*SUWA comments re. Draft map PEIS*

July 10, 2006

Re: Southern Utah Wilderness Alliance Scoping Comments  
Preliminary Draft Utah Energy Corridor Map  
PEIS – Designation of Energy Corridors on Federal Lands in the 11  
Western States<sup>1</sup>

2. Alternative route identified for the Western Energy Corridor System:

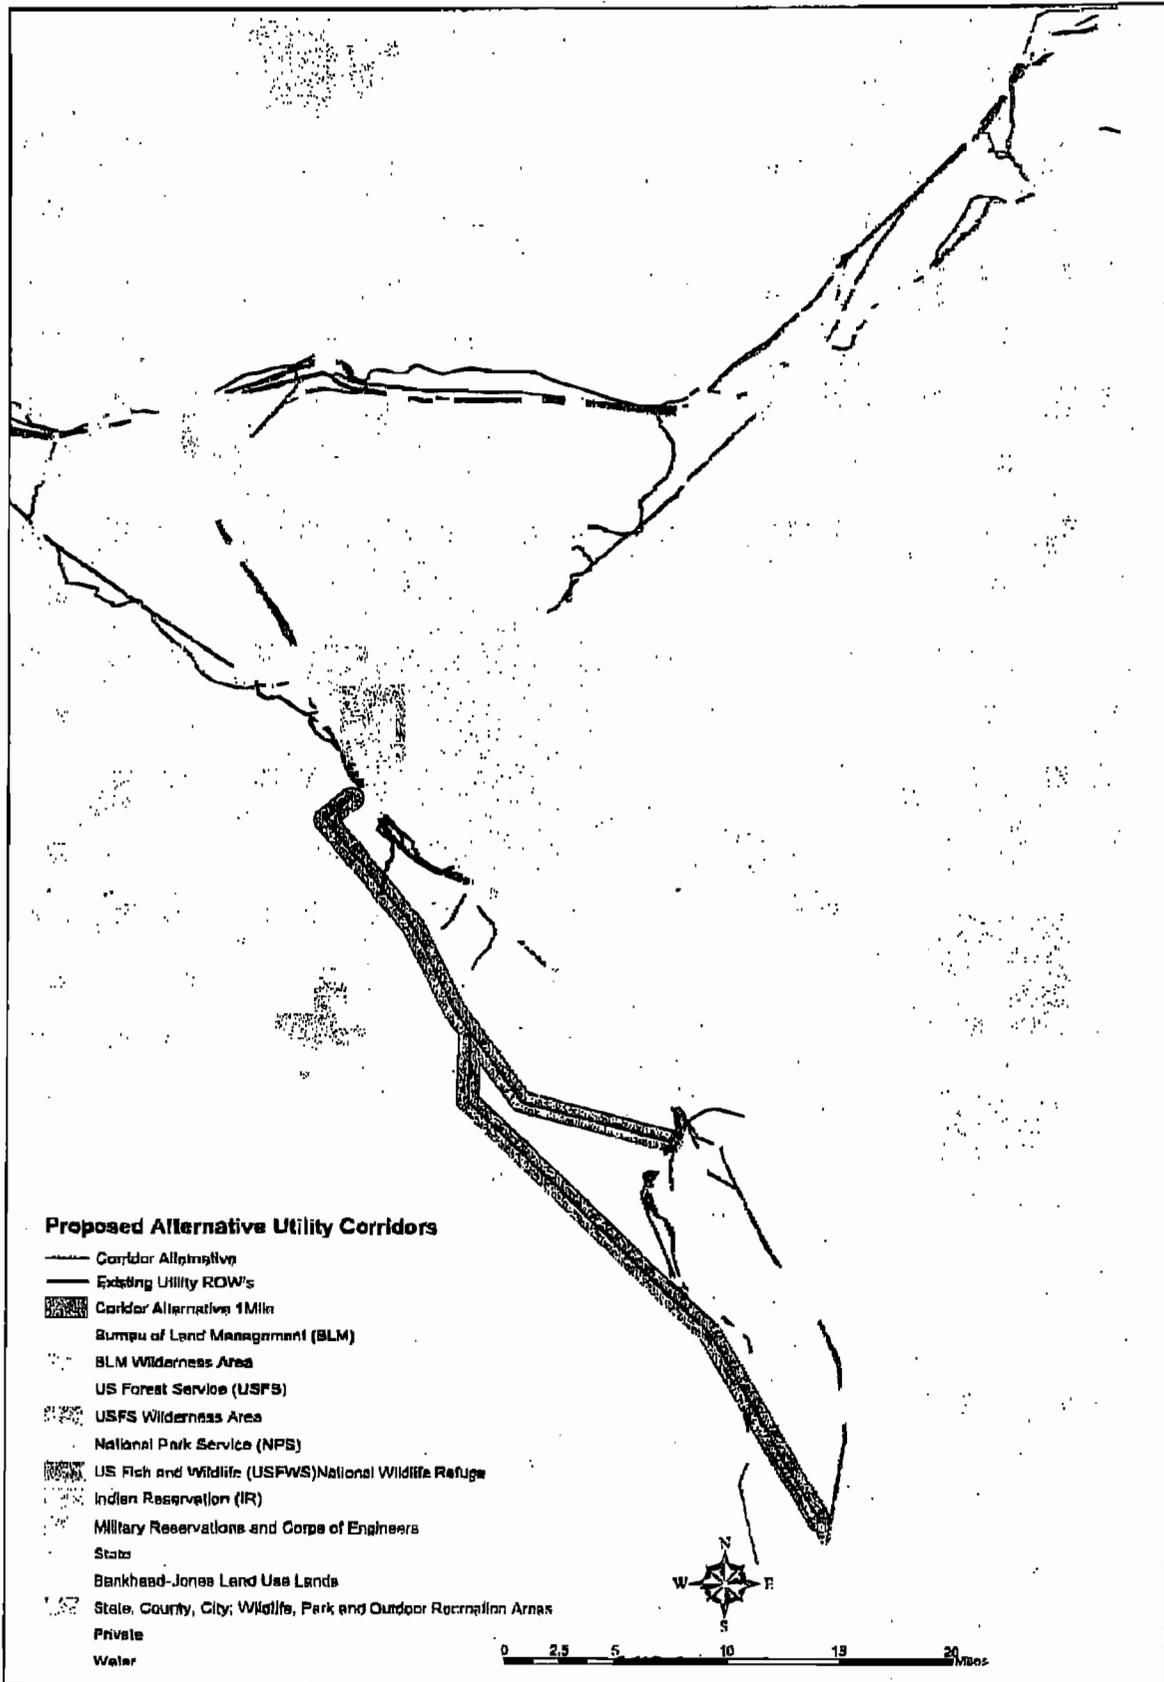
The straight-line route currently being considered for the EIS was modified, with two variations, to avoid Dead Horse Point State Park and the private and state land used by Intrepid for the Moab Salt potash mining operation. The corridor would be 1 mile wide to allow flexibility in utility placement. A single structure could span the Colorado River, from rim to rim, to support all utilities.

The alternative route would be 23 miles long leaving the existing corridor in the area of SR-313 and rejoining the corridor south of Behind the Rocks, and approximately 27 miles long rejoining the corridor west of La Sal Junction.
